LOT 27 RESERVE ROAD, MUCHEA

PROJECT
Proposed Brewery
Lot 27 reserve Rd
Chittering

Wastewater Management Plan

Response to email questions from Stephanie Gladman, Planning Officer, Shire of Chittering
RE: "HAGAN'S BREWERY": Reserve Road, Chittering

Figure 1: Dimensioned Floor Plan – Brewery and Public Areas

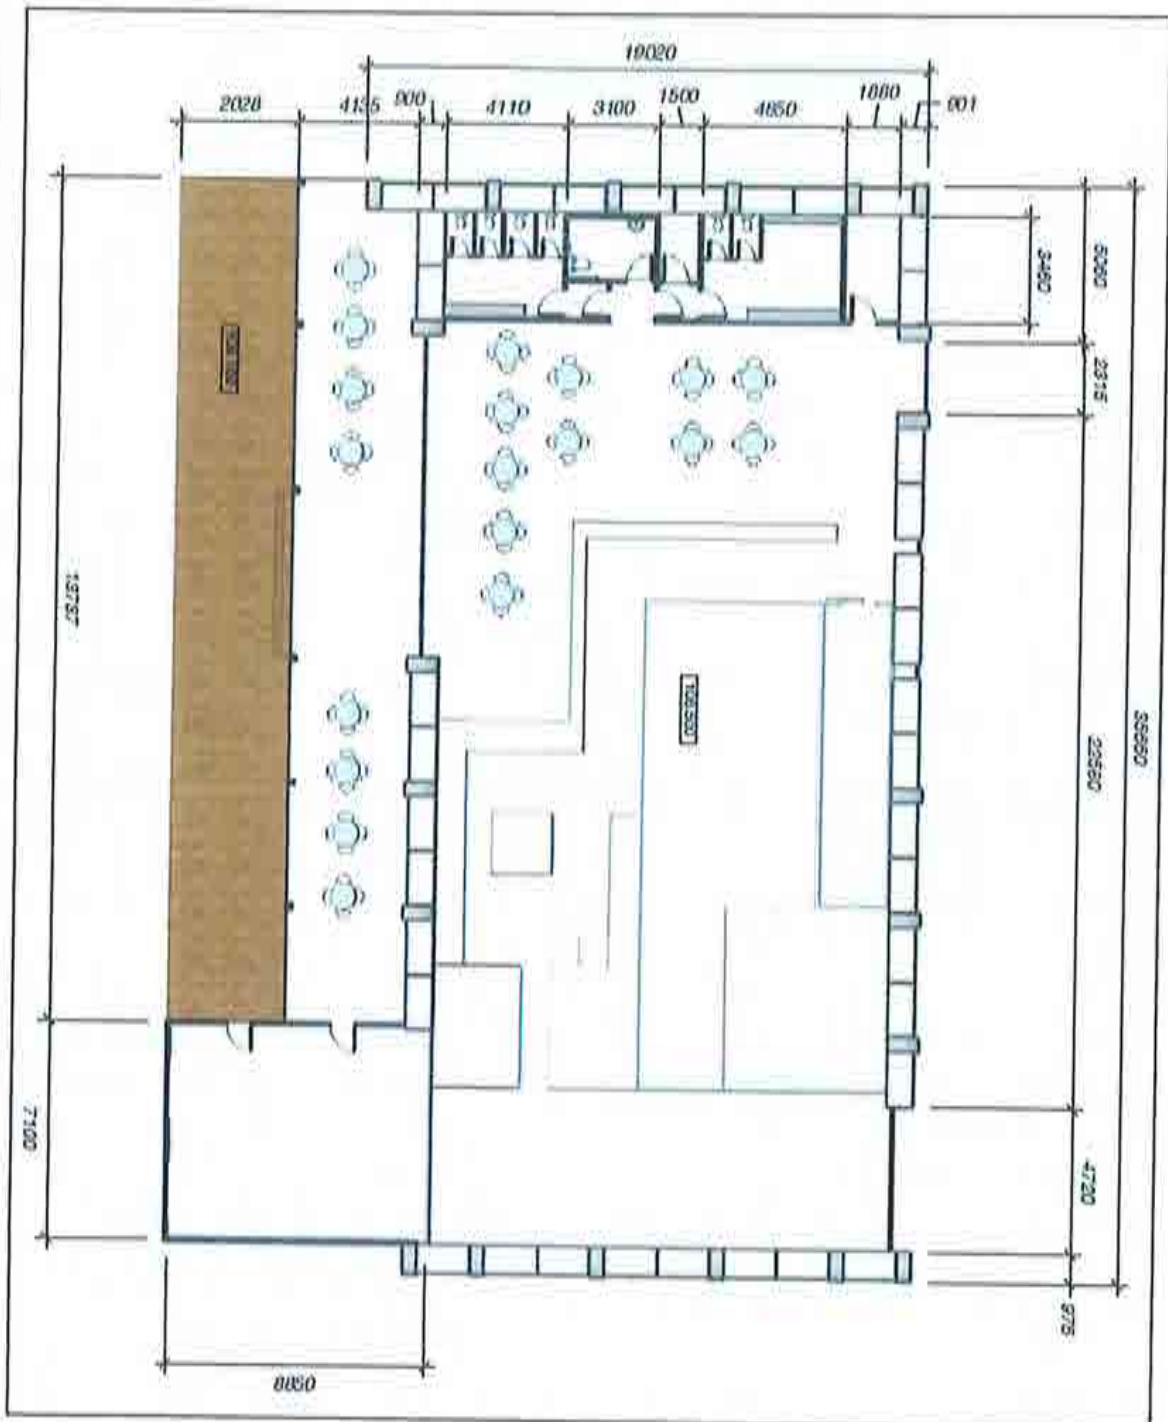
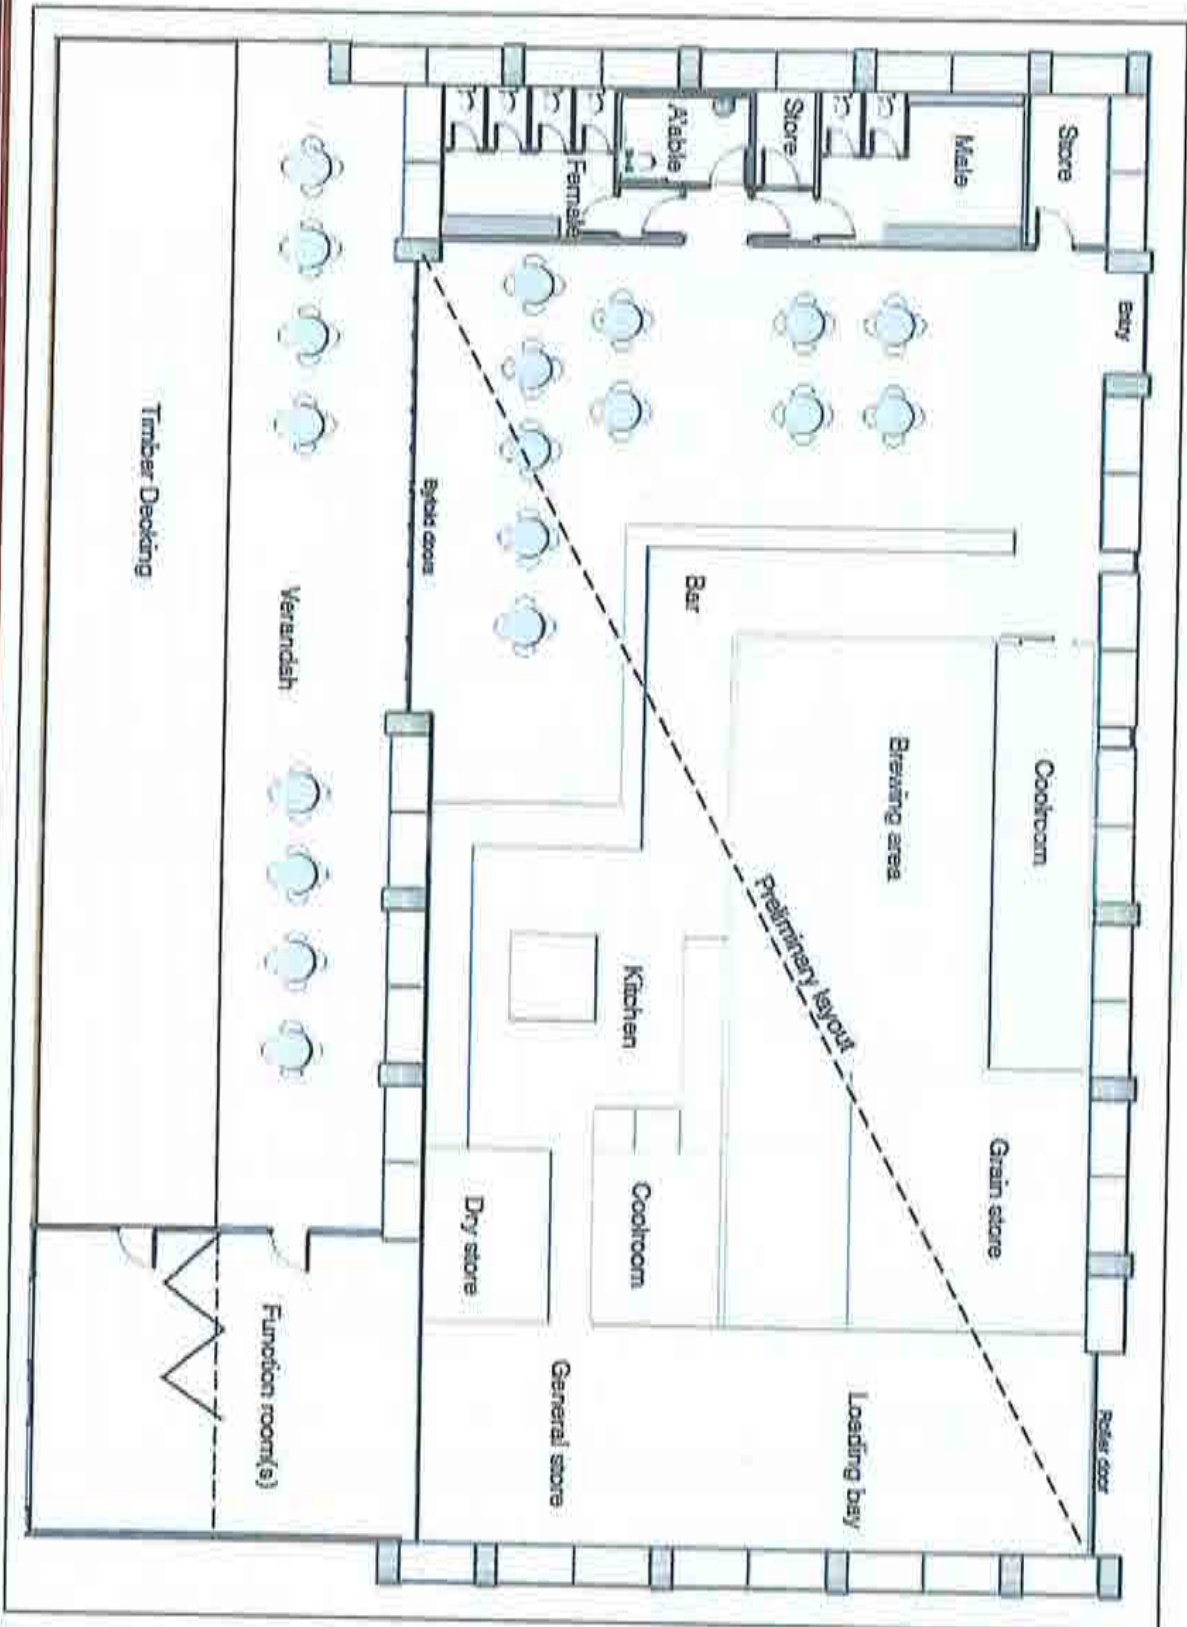
1. How is the 250 person maximum accommodation number calculated? Provide a breakdown of numbers in each area.

The suggested number of 250 patrons is subject to the final floor area accessible to the public.

The WWTP includes an approximate breakdown of the floor areas at 1.3. Based on those calculations, the total floor area of the bar, verandah and function rooms is around 258m². Based on a conservative estimate of patronage, the number of 250 was suggested. However, per the Public Buildings legislation, the formal public building calculations based on the current plan would be as follows:

- Bar Area - ~110m² @ 0.85m²/patron = 129.41 (129) patrons*
- Verandah Area - ~85m² @ 1m²/patron (could also be 0.85m²/patron but allowance made for some seating) = 85 Patrons*
- Function Rooms - 63m² (combined) @ 1m²/person = 63 patrons*
- Total patrons therefore equals 277 for the public areas within the confined of the building.*

Figure 3: Site Plan of Effluent Treatment and Wastewater Disposal

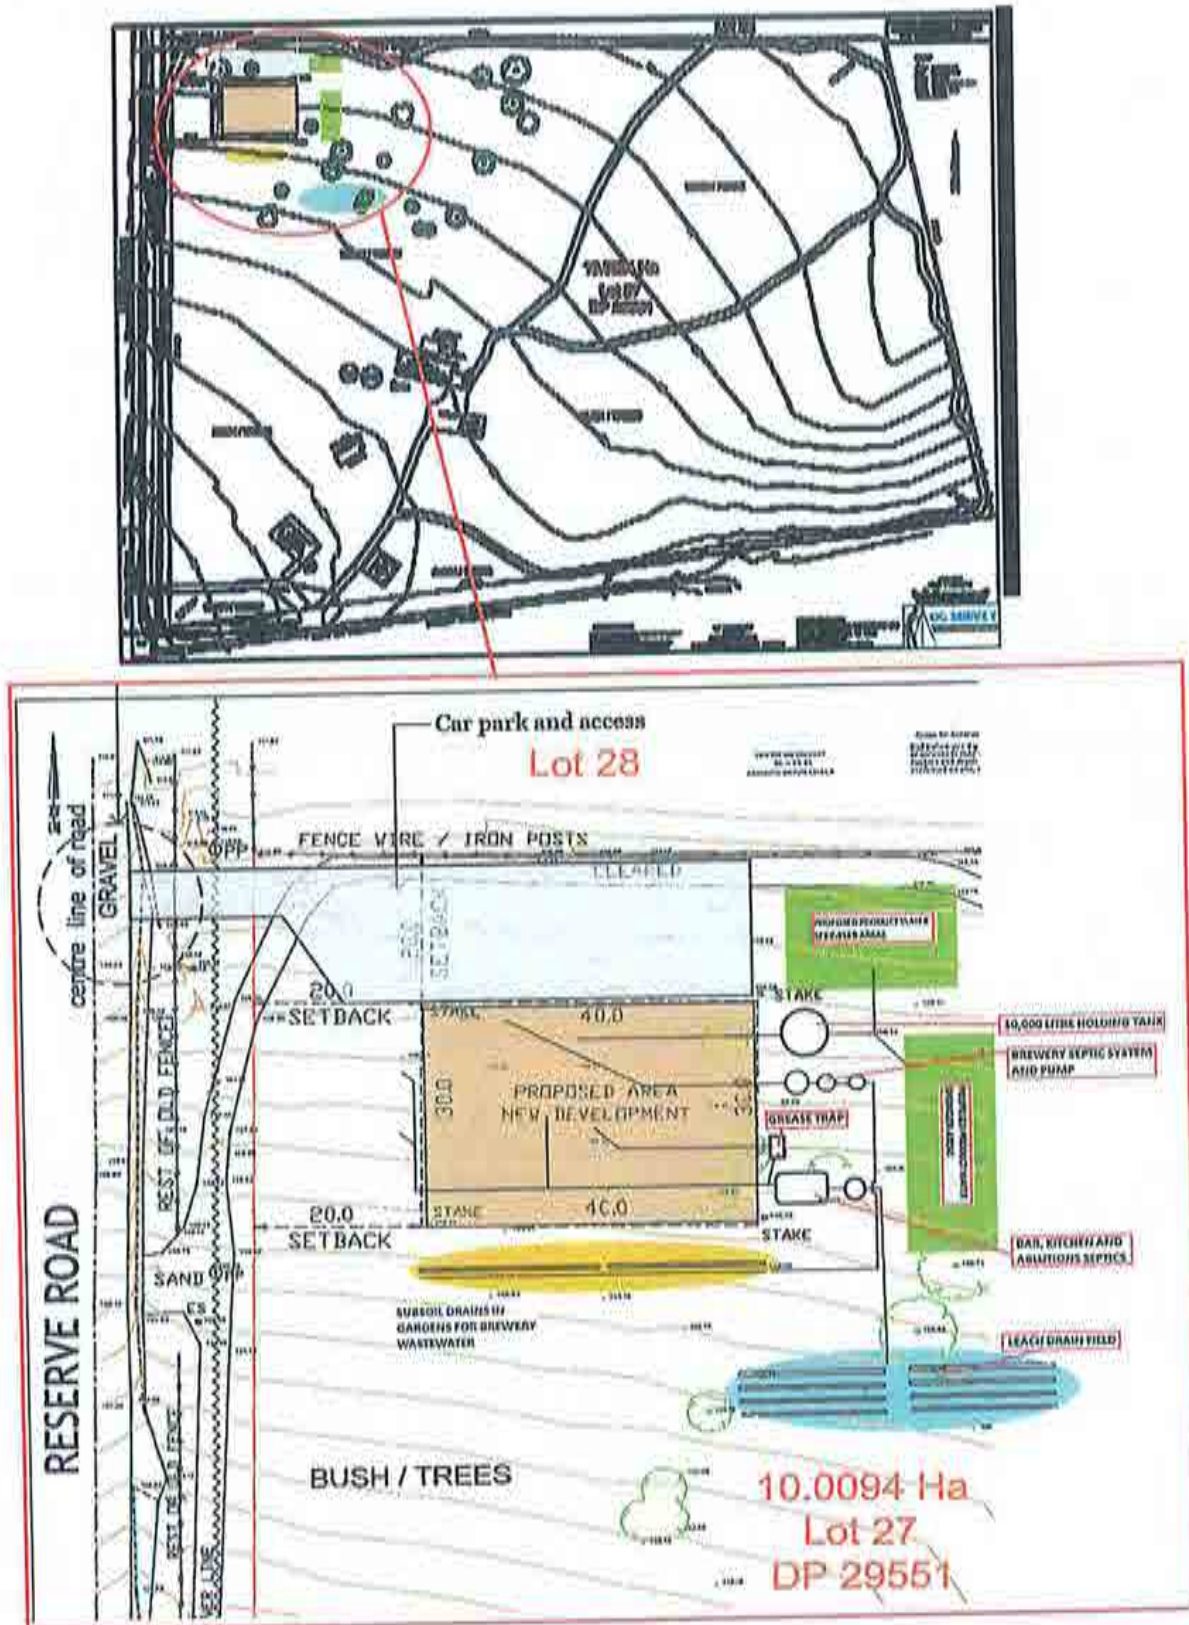
9. The large septic tank if constructed on site will have to have engineers specification and be baffled 2/3 and 1/3. Consideration could be given to modular tanks in series (with baffles if over 2200 litres).

10. How will leach drains be alternated? How frequent?

11. Are there any issues with the disposal water in the sprinkler area, eg aerosols with pathogens? Will this area be fenced off/signed? Will there be any wind blow towards the factory or patron area? Would sub soil disposal be safer?

The proponent is aware of the Regulations governing the installation of apparatus for the treatment of effluent and would employ the services of a structural engineer if it was deemed more economic to construct a single concrete tank. Precast tanks in series may be considered but this option would depend on cost and also the area available for the siting of this apparatus.

The septic tank will be connected to the leach drains via a diverter valve. This will be operated manually and it is likely that the drains will be alternated every three months.

Sub soil disposal was assessed but considered unnecessary. Because the produced water is generally coming from a sterilised environment, and the additives to the cleaning water would limit the development of pathogens, no issues with above ground sprinklers are expected. However, the following management practices will be followed:
